AIRWORTHINESS DIRECTIVE

No. 2019-FATA-01020A-09

Applicability – RRJ-95 aircraft

TECHNICAL DECISION RRJ0000-OR-470-3330

Fig. 1 (For illustrative example is shown slat section 4)

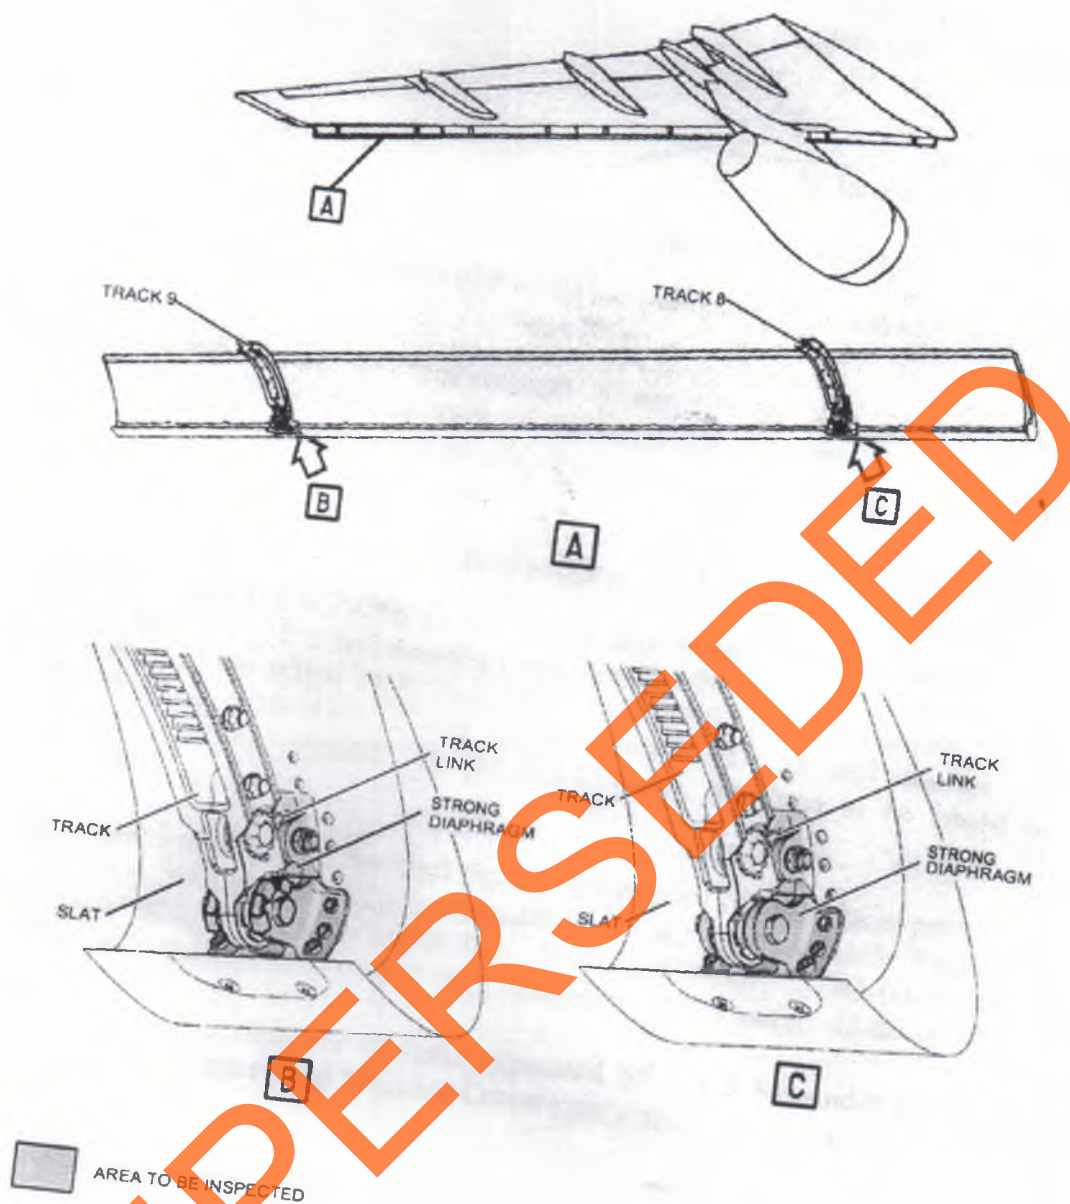
1. On weekly basis of WY-Check/8 DY maintenance to perform "Detailed inspections of slat sections 1, 2, 3 and 4 strong diaphragms on the left and right outer wings" (See Fig.1) IAW AMM Tasks Nos. 57-42-00-220-801, 57-43-00-220-801, 57-44-00-220-801 and 57-45-00-220-801 on operated RRJ-95 fleet until issuance of a separate Technical Decision by the Manufacturer, which is to be issued on 15.08.2019.
2. In case of a detection of the crack during performance of the tasks as per cl. 1 – to perform replacement of the corresponding slat section IAW AMM Tasks No. 57-42-00-900-801, 57-42-00-900-803, 57-43-00-900-801, 57-43-00-900-803, 57-44-00-900-801, 57-44-00-900-803, 57-45-00-900-801 and 57-45-00-900-803.
3. The results of completion of tasks stipulated by cl.1-2 hereunder are to be reported to the Operational Situation Center customer@scac.ru.
